XEROX EOD	Project DO	RDC Logic Changes	File RDCChanges2.sil	Designer J. F. Cameron	Rev Gb	Date 9/3/79	Page 18
--------------	---------------	-------------------	-------------------------	---------------------------	-----------	----------------	------------

SPLAT A

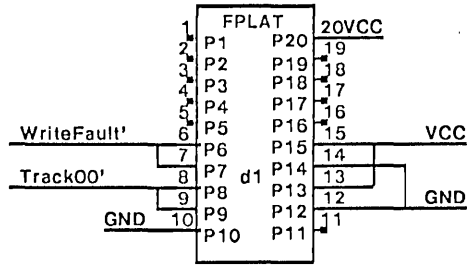
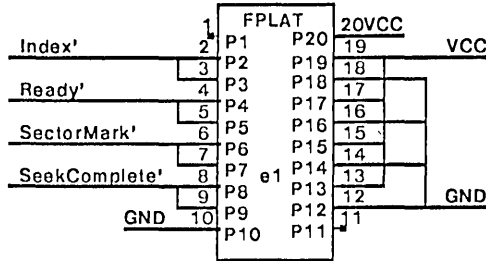
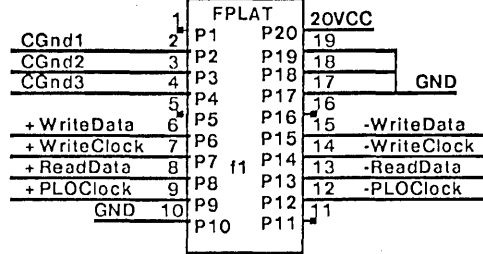
- 1) Redrew splats at d1, e1, f1 as FPLATS to avoid ROUTE trace cuts (pg 17).
- 2) Added spare positions at g3, h9, i9, e17, b10, c10 (pg 17).

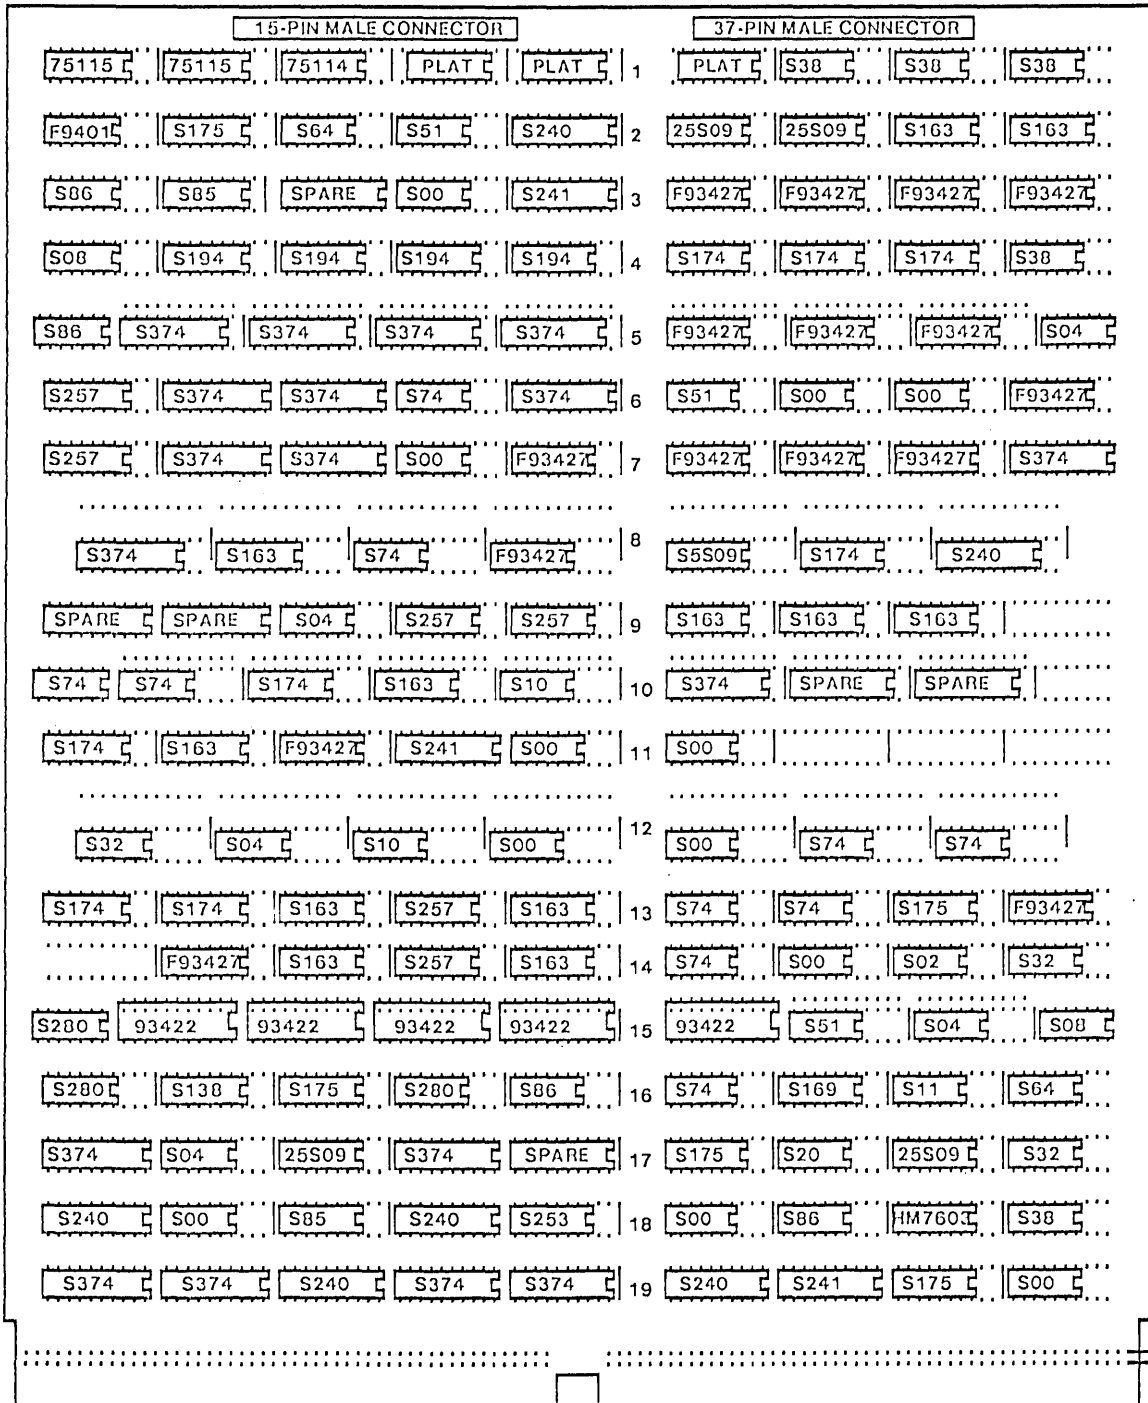
Rev Gb: 9/3/79 - CPT

This change is a manual addition to the revision Ga MultiWire board.

1) Lift the following pins:

a15.12
c16.9
d10.6
i13.10
a13.15

2) Add an S174 IC in position i9, and wire i9.16 to Vcc.

3) Add the following wires:

a15.12 to i16.9 (DevSelOK, pg 2,16)
c16.9 to a15.11 (RstAbrt/Err', pg 3,2)
d10.6 to a15.9 (ClrDevOpS', pg 12)
a15.8 to h13.1 (ClrOp', pg 4,7 - new signal name)
a15.10 to a15.5 (IRun, pg2,12)
i13.10 to i9.4 (Unnamed signal - was InhHdrAbrt, pg 4)
h13.7 to i9.3 (Unnamed signal - was VerifyLabel, pg 4)
i11.9 to i9.9 (OpRegClk', pg 4)
i11.1 to i9.1 (RstAbrt/Err', pg 4)
i9.5 to a13.1 (InhHdrAbrt, pg 4,12)
i9.2 to a13.15 (VerifyLabel, pg 4,12)
